Technical Service Bulletin: TSB120287

Released Date: 21-Dec-2012

K/QSK19 Edge Molded Rubber Oil Pan Adapter Gasket

New Oil Pan Adapter Gasket, Part Number 2888747

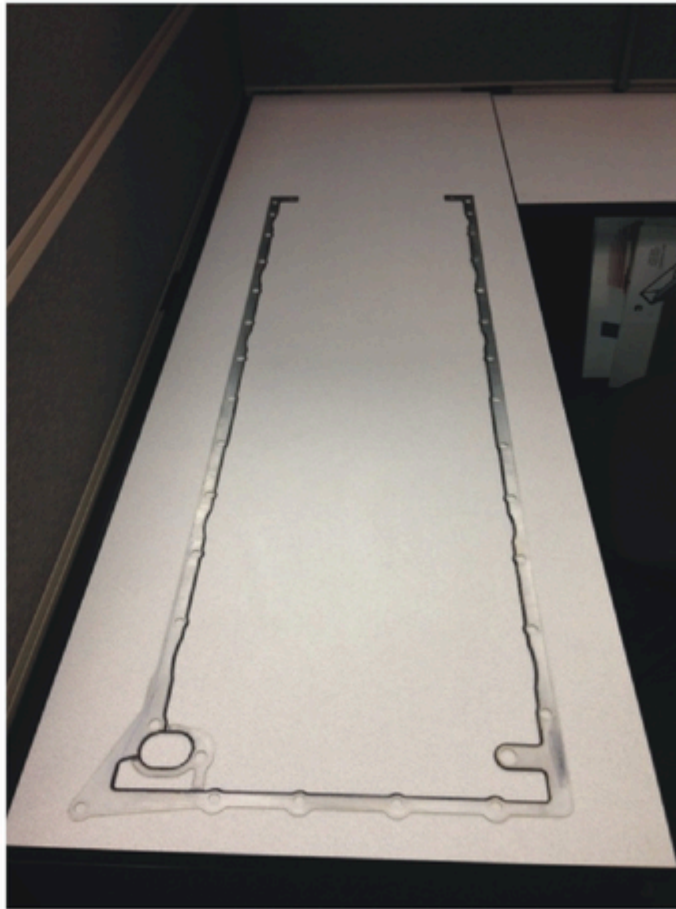
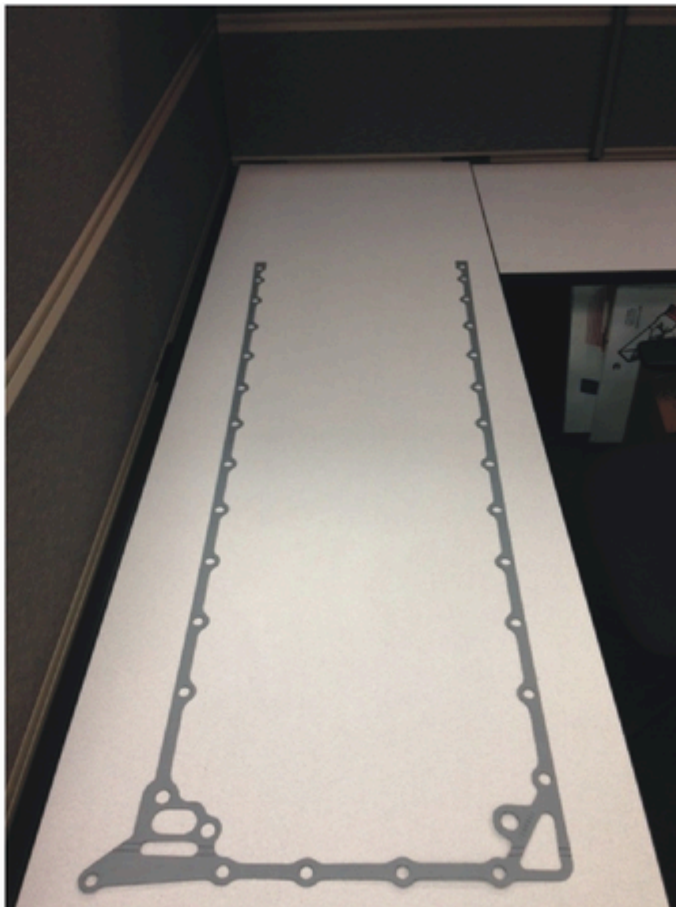
This document announces the release of a new style oil pan adapter gasket. The new edge molded rubber gasket is being released to address oil leaks at the oil pan adapter joint. This new oil pan adapter gasket utilizes a metal carrier and edge molded rubber to prevent capscrew preload loss at the oil pan adapter joint.

All QSK19 engines built in the Seymour Engine Plant as of 11/15/2012 build date will use oil pan adapter gasket, Part Number 2888747. ESN first for this change is 37256362. At this time, the K series engines will continue to be built using oil pan adapter gasket, Part Number 4000595.

Oil pan adapter gasket, Part Number 4000595, will **no** longer be used in service. All kits containing oil pan adapter gasket, Part Number 4000595, will now contain the new oil pan adapter gasket, Part Number 2888747. The effective date for this change at the Part Distribution Centers is 12/15/2012. It is important to note that oil pan adapter gasket, Part Number 2888747, can be installed on K series engines also.

Installation of this new gasket is critical to the gasket's ability to seal properly. The proper installation procedure must be followed in order to maintain a leak free joint. The installation procedure can be found in the service manual for the engine being serviced, in Procedure 007-027 (Lubricating Oil Pan Adapter).
